HYDE PARK CITY
LAND USE AUTHORITY
March 8, 2016

DISCUSSION ON PROPOSED CACHE VALLEY MORTUARY

MORTUARY SITE PLAN (Platinum Const.)
PLAN VIEW OF PROJECT
4200 NORTH & 75 West (Easement)
SEWER, WATER, ROADWAY Etc.

MORTUARY SITE PLAN (Platinum Const.)

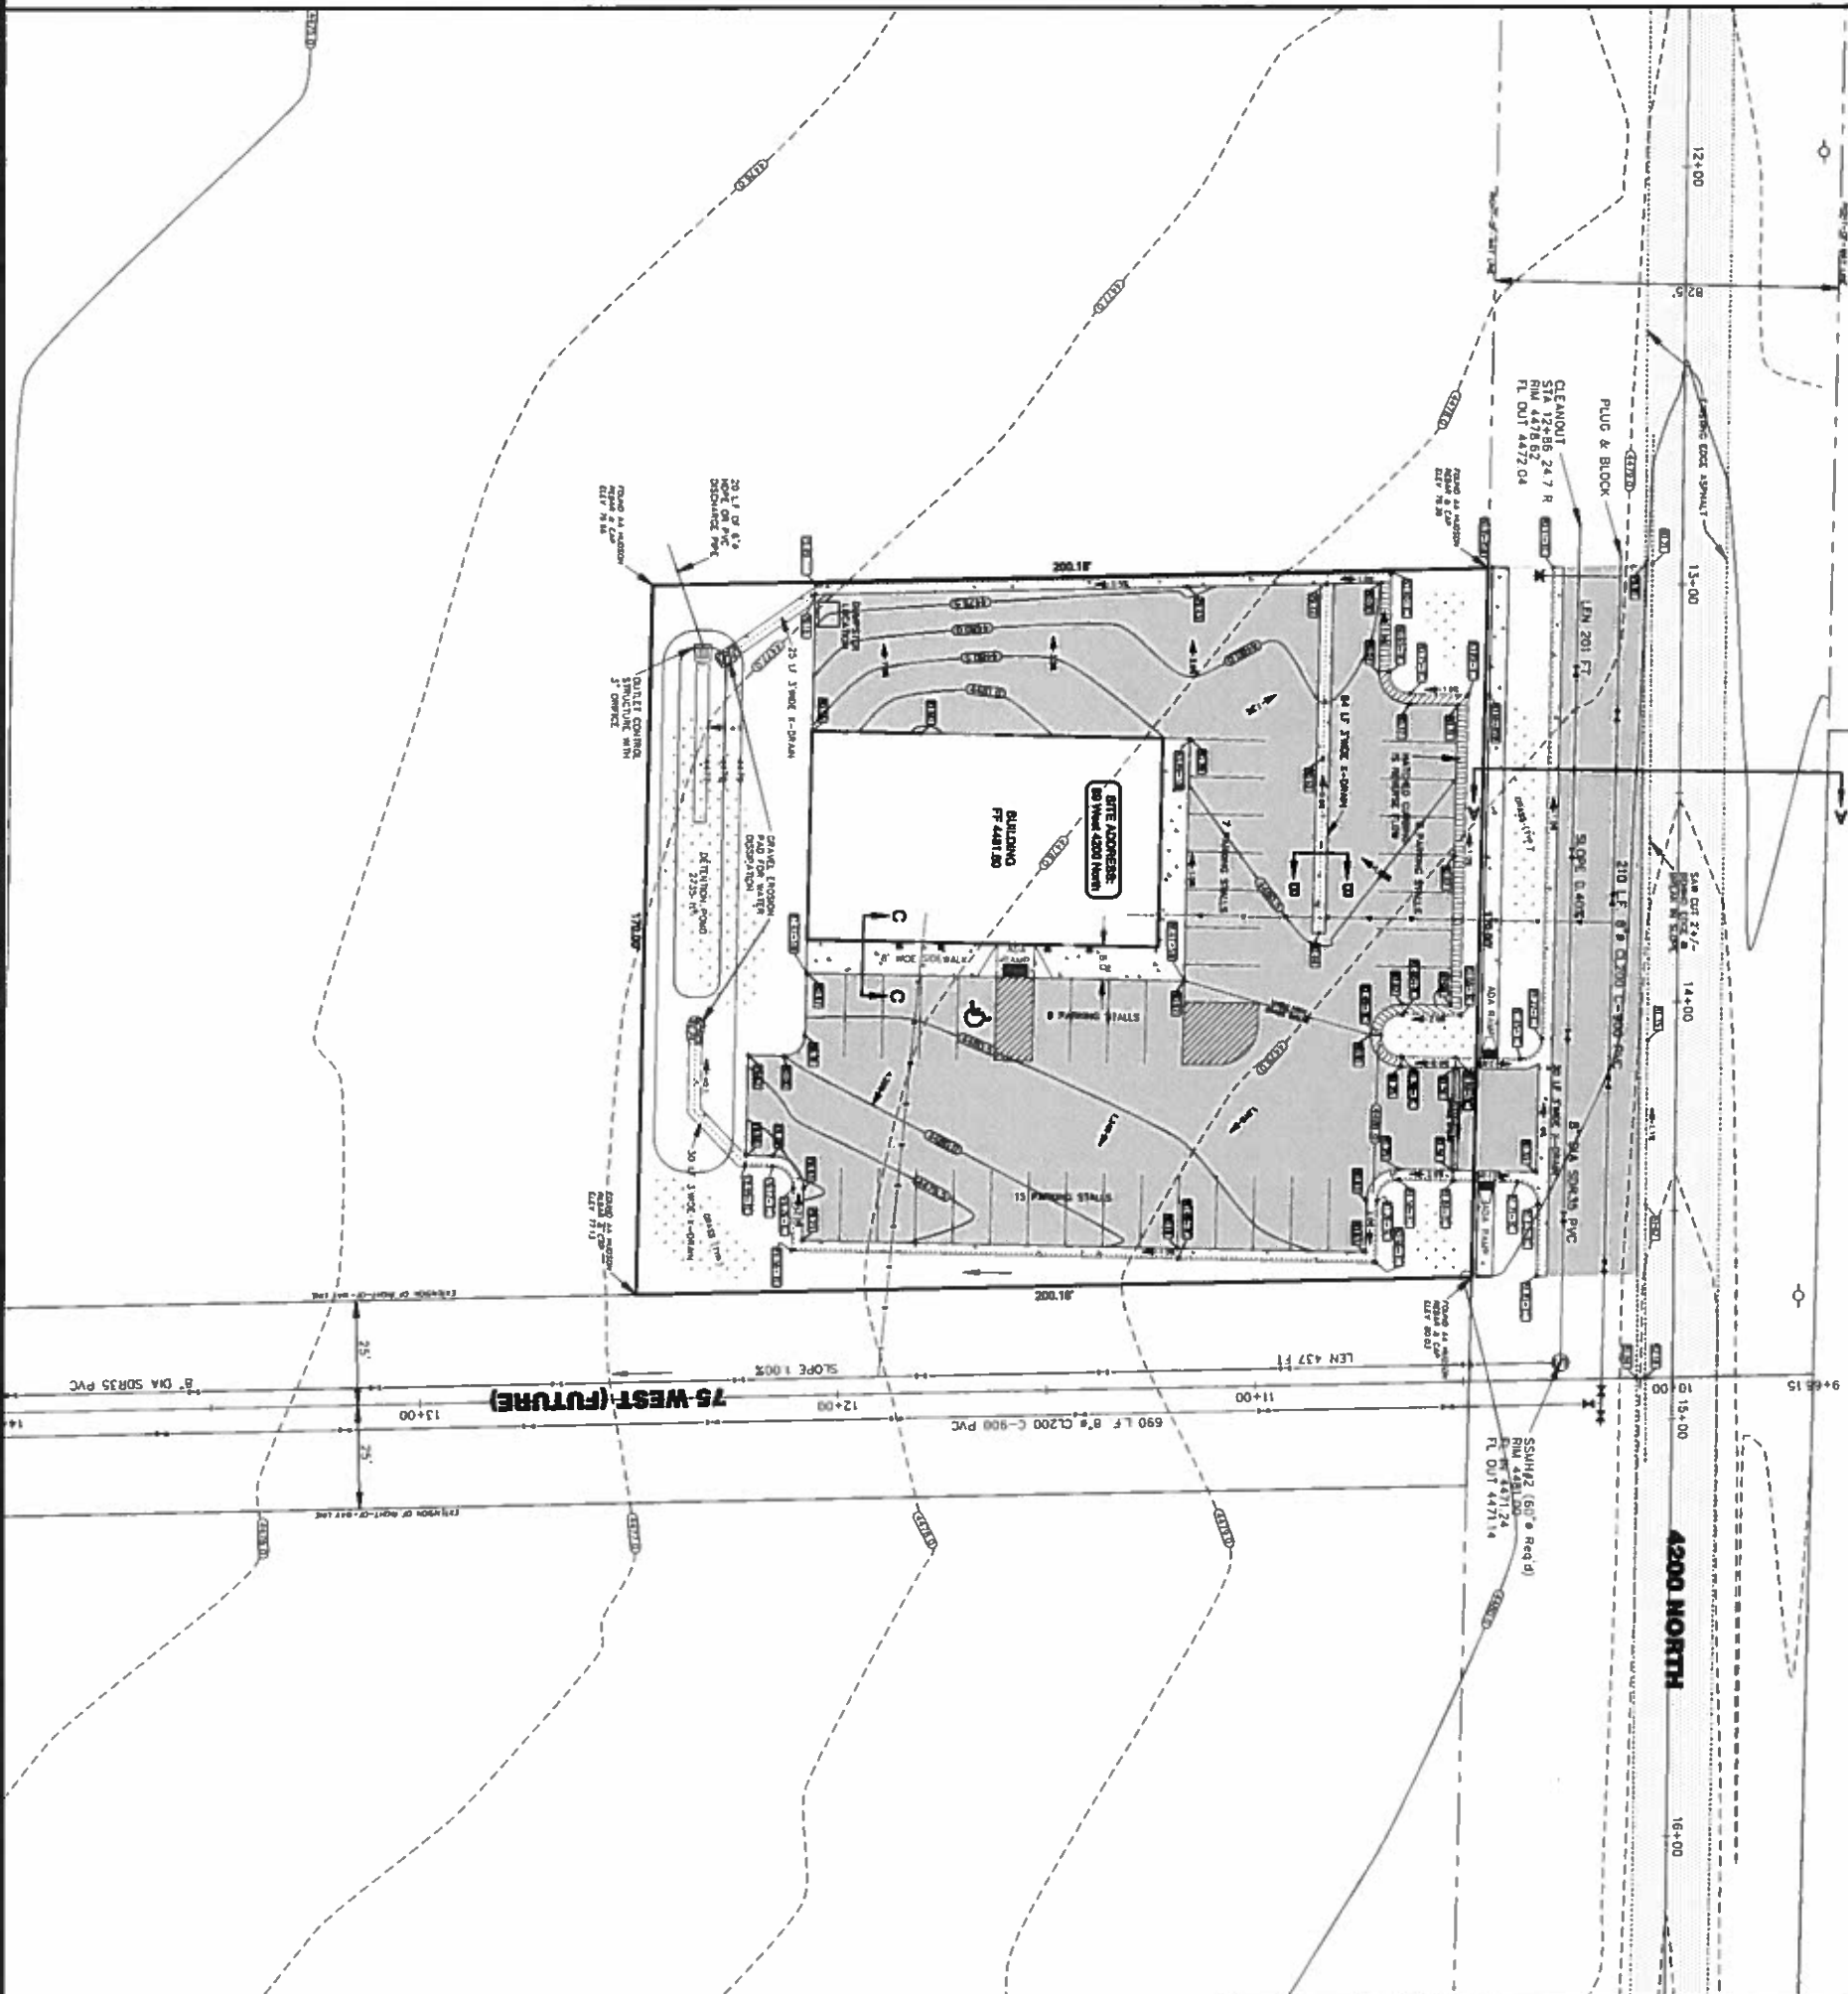
The LUA held a discussion with Ben Johnston, regarding infrastructure for this development. The right of way is larger than the cross section specified for this roadway. The extra footage will be put into the park strip.

The water line will be extended from the north of Agri-Service on 75 West to the 4200 North roadway.

Mike and Max discussed with Ben the valves needed and the hydrant location. The sewer line will also go to the 4200 North road in the right-of-way. They discussed depth and location of clean outs. The stormwater will be retained in a pond on the south of the lot. It has sufficient capacity. Ben will design it to flow to 200 West once development progresses in the future.
